3717 s alaska st

Design Review - 2nd Recommendation

June 7, 2016

SDCI Project # 3019517

ENLARGED PLAN AT NE CORNER north

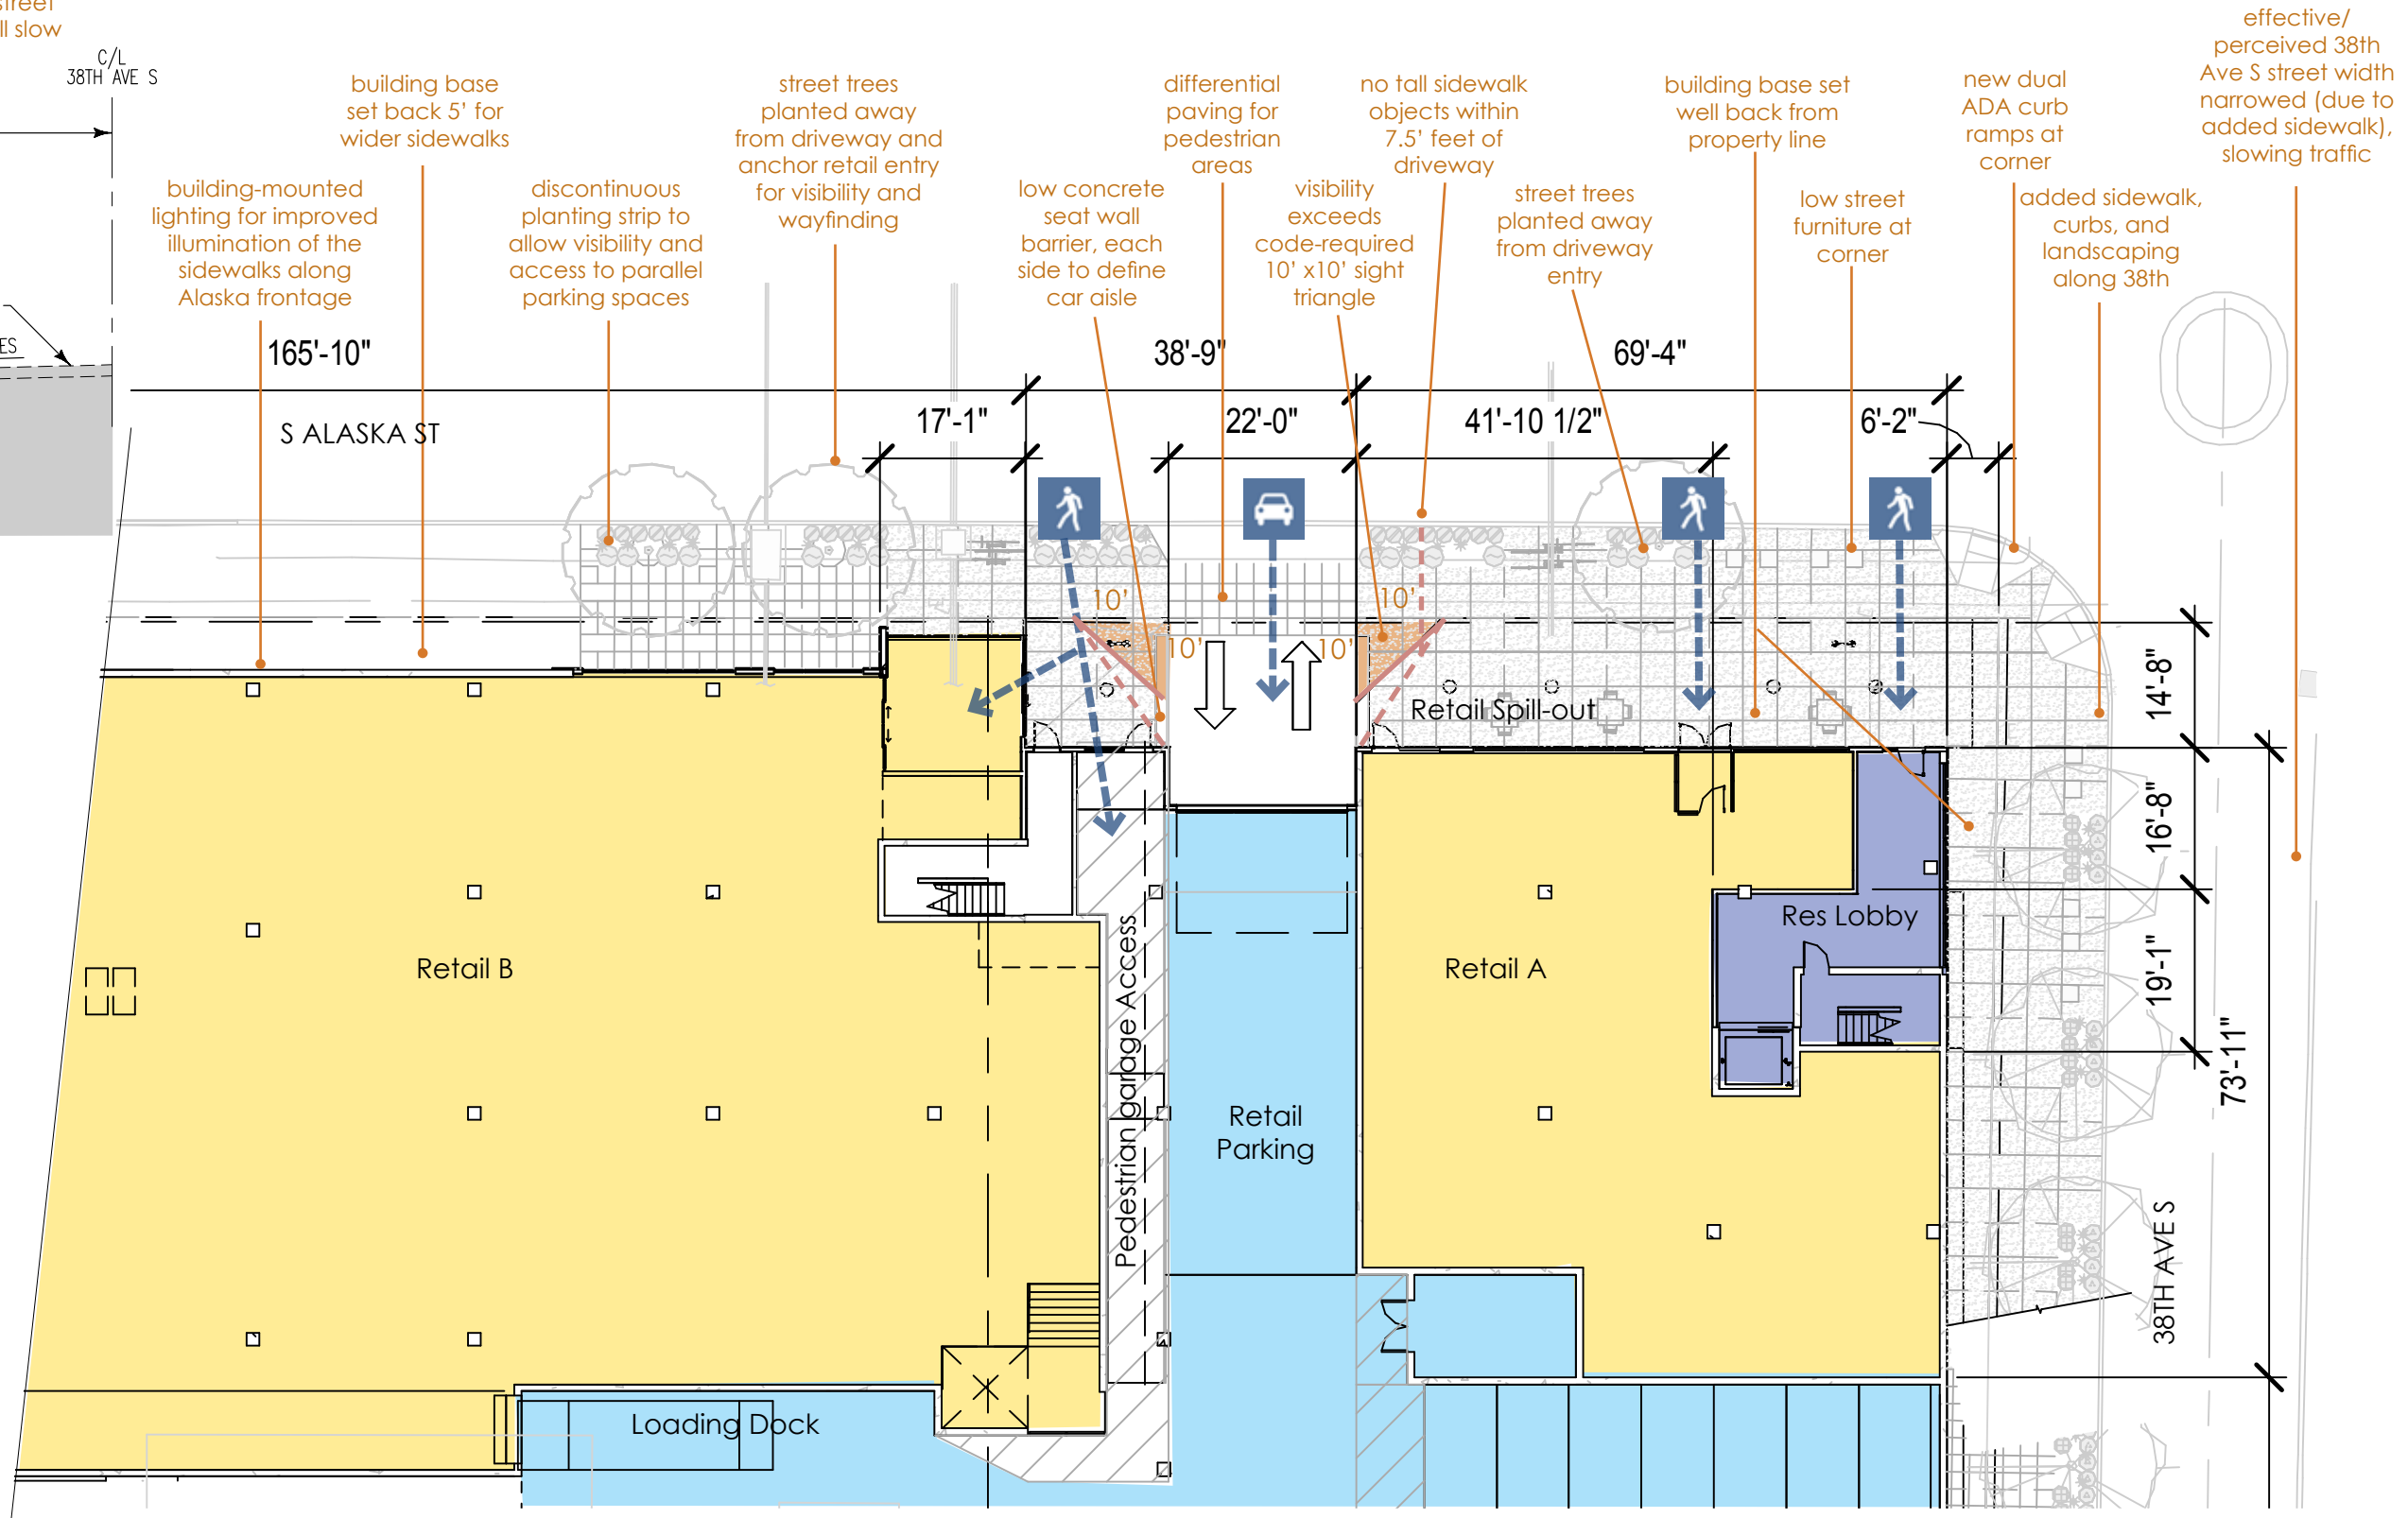
- Board Guidance: due to concerns about the ground-level visibility at Alaska-38th intersection, consider expanding the street-level setbacks at the NE corner to create sightlines. Provide additional detail on pedestrian safety measures at the retail garage entry.

- Board Guidance: provide street furniture and pedestrian amenities along the streetscape to engage and foster human interaction. Increase retail opportunities for street interaction and study the relationship of the lower lobby and Retail A entries

Design Response: Alaska-facing facade of Retail A has been pulled back significantly from the property line to allow spill-out space adjacent to the sidewalk, views from Alaska around the corner to 38th, and enhanced views to the street when exiting the retail garage. The streetscape surrounding the retail garage entry has been carefully studied, with input from our traffic consultant to enhance sightline and safety: street trees have been pulled away from the garage entries for visibility, and pedestrian space is defined by differential paving and seat walls.

Design Response: Street furniture has been added along the Alaska St frontage, concentrated near site entry areas (hillclimb entry, Retail B entry, and NE corner Retail/lower lobby entrances). Retail A has been reconfigured with large spill-out space in the enhanced ground floor setback from the sidewalk and a direct Alaska-facing entrance to increase its street presence. To accommodate parallel parking along S Alaska and a strong retail connection with the street and park, a discontinuous landscape strip is proposed at the sidewalk edge to allow for greater porosity and visibility for pedestrians on the sidewalk.
